RE: Whitewood Creek Restoration, Deadwood SD
Sites 1C, 2A, 2B, 3A, & 3B
Cost Proposal #05 – Proposal Request No. 5 (January 23, 2024)

REQUEST FOR PROPOSAL

Whitewood Creek Restoration – BP #1

PROPOSAL REQUEST NO: 5

S-304

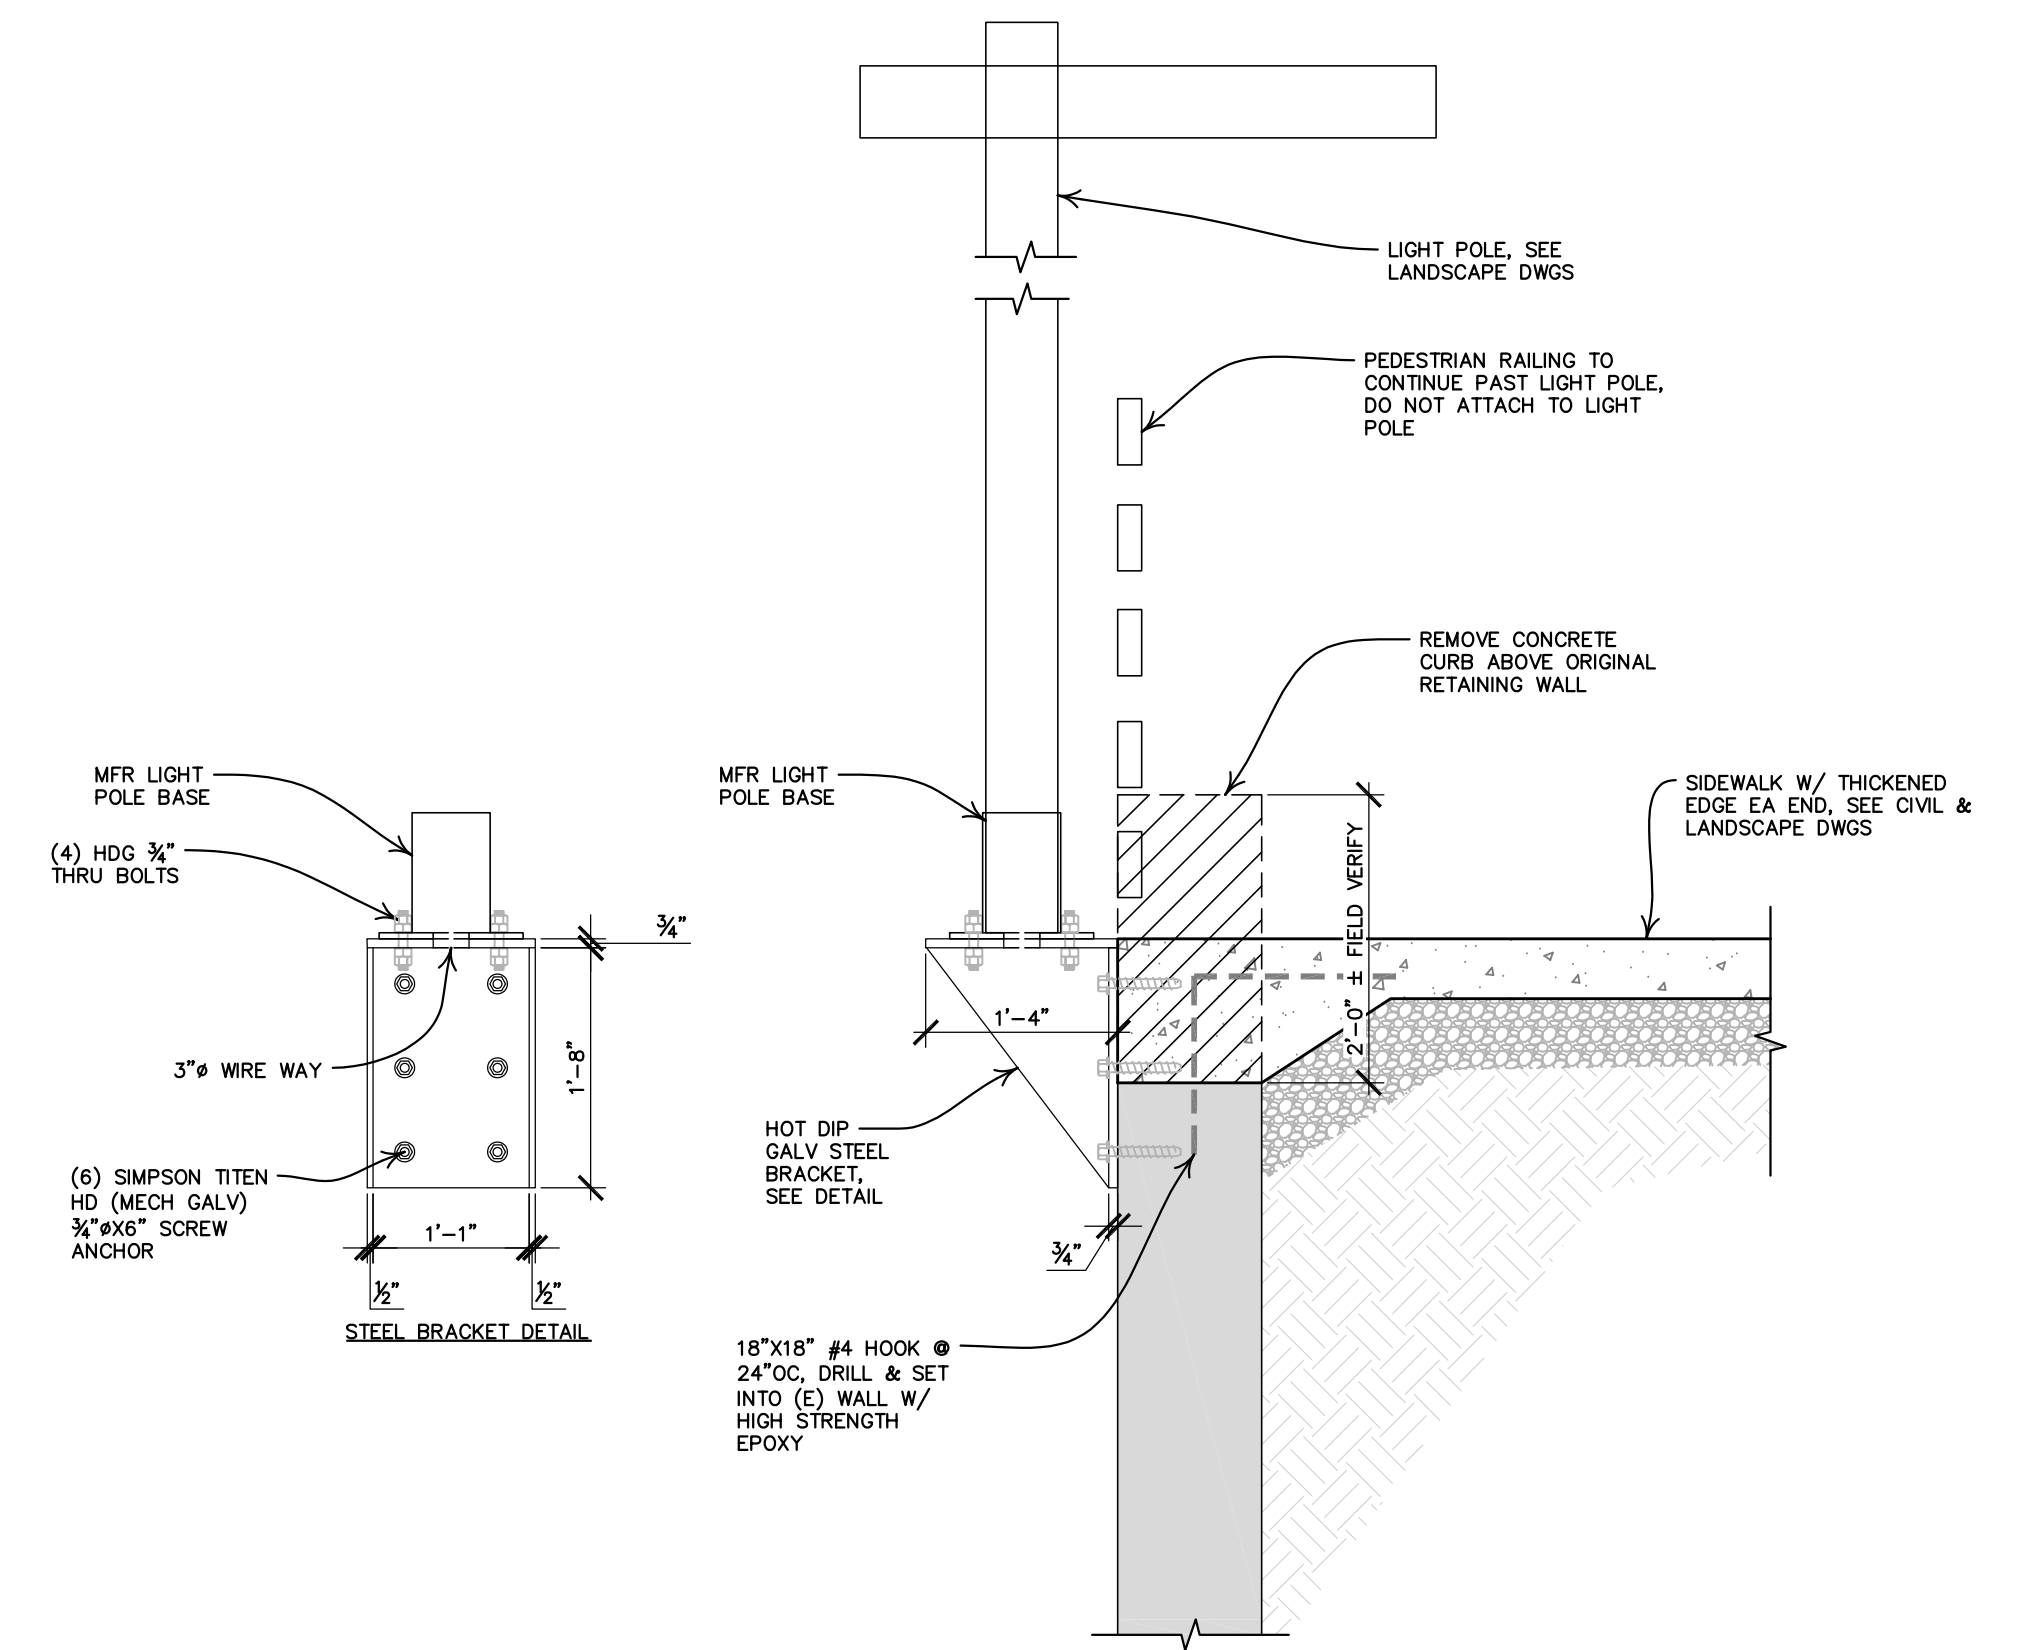
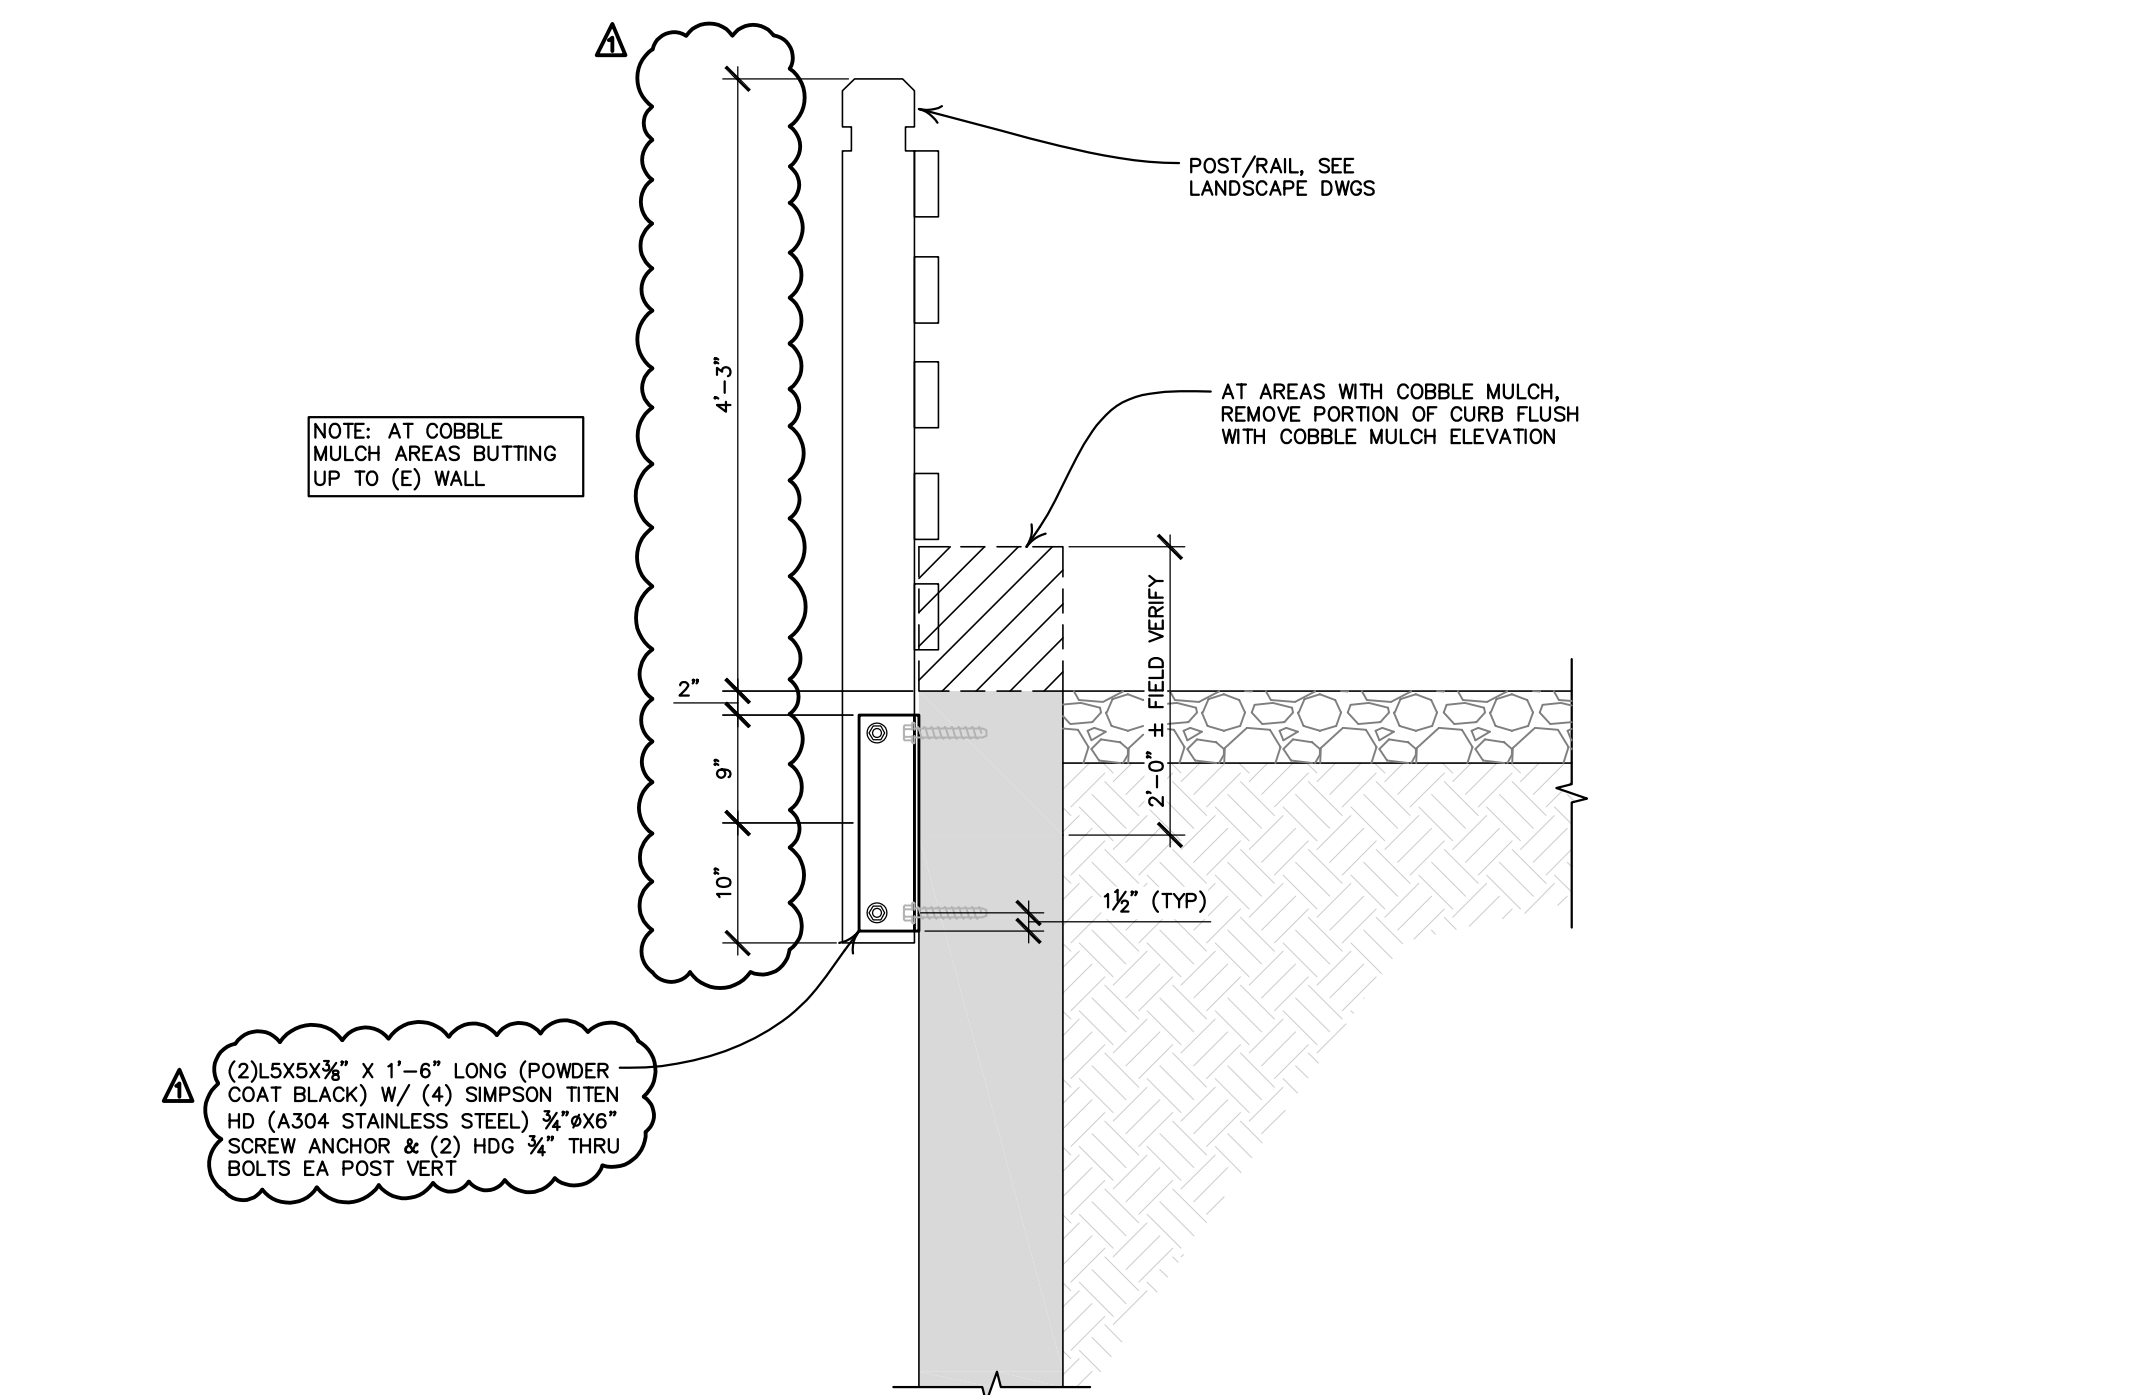
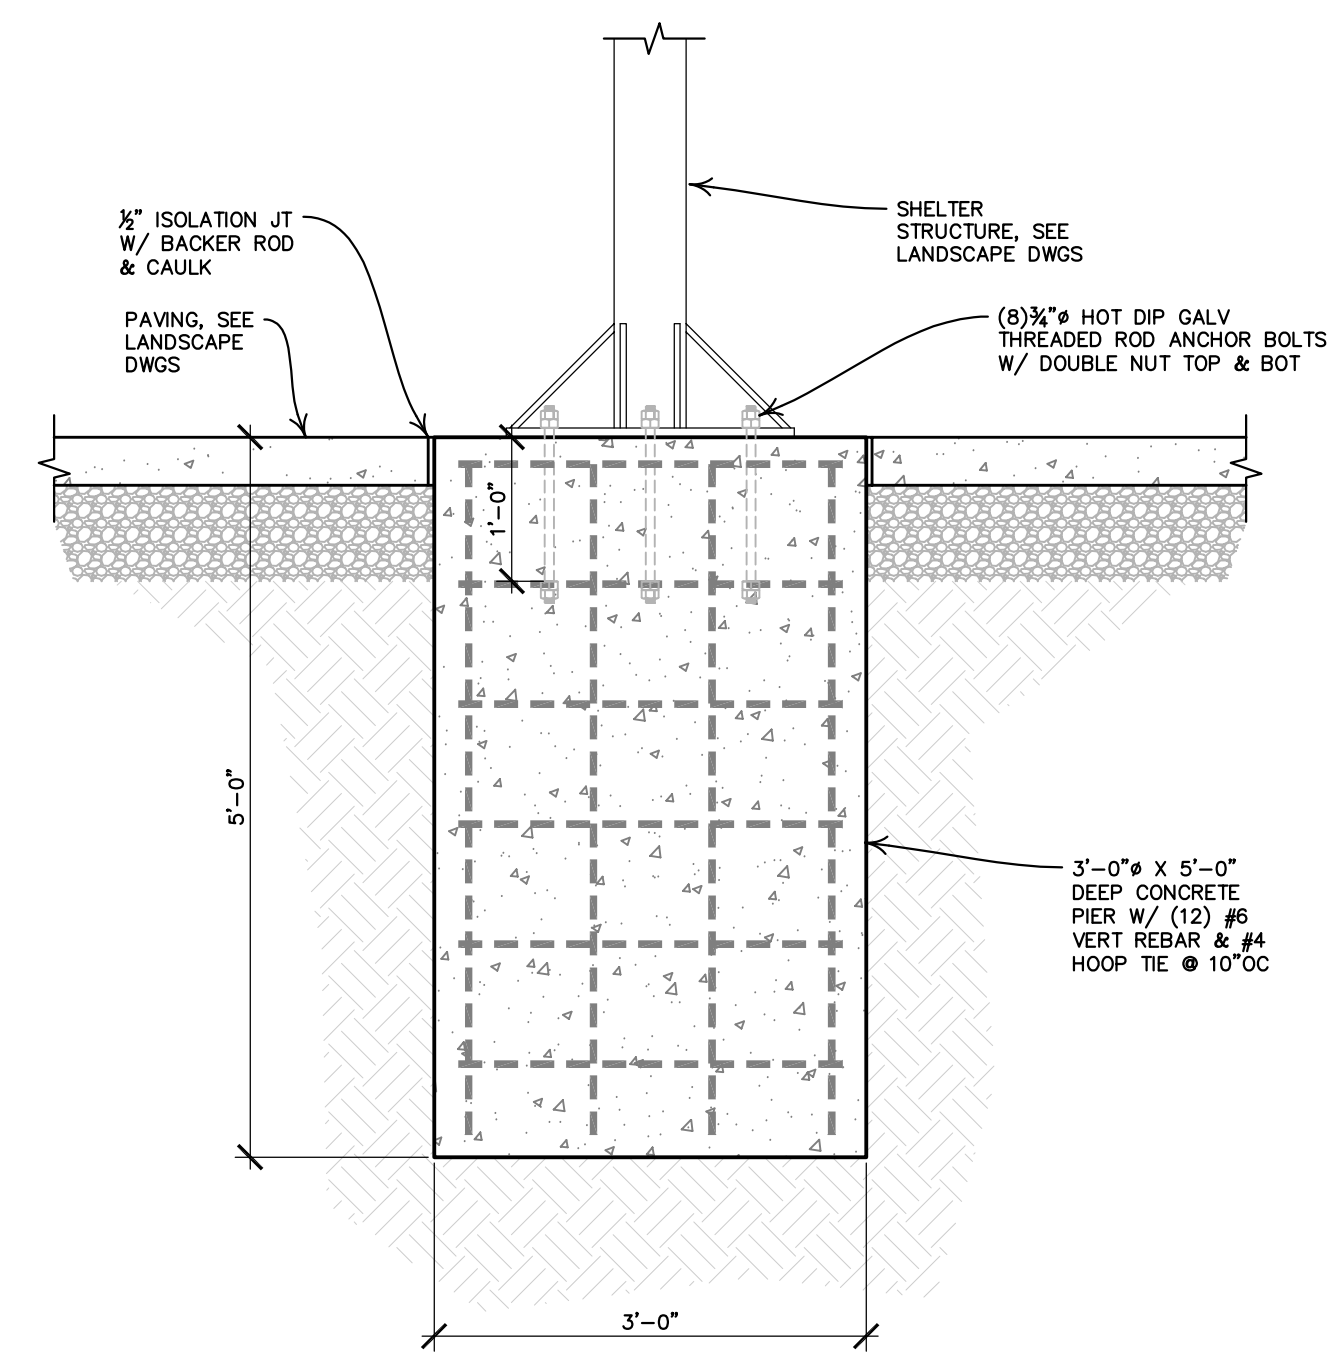
1. 6'-0" long posts can be utilized along the pedestrian railing that is directly attached to the sidewalk edge. The steel angle location shall be adjusted. Also, the concrete screw anchors that fasten the steel angles to the concrete shall be changed from a mechanically galvanized material to stainless steel. See attached Sheet S-304.
2. See attached LASI 2 by Tallgrass Landscape Architecture.
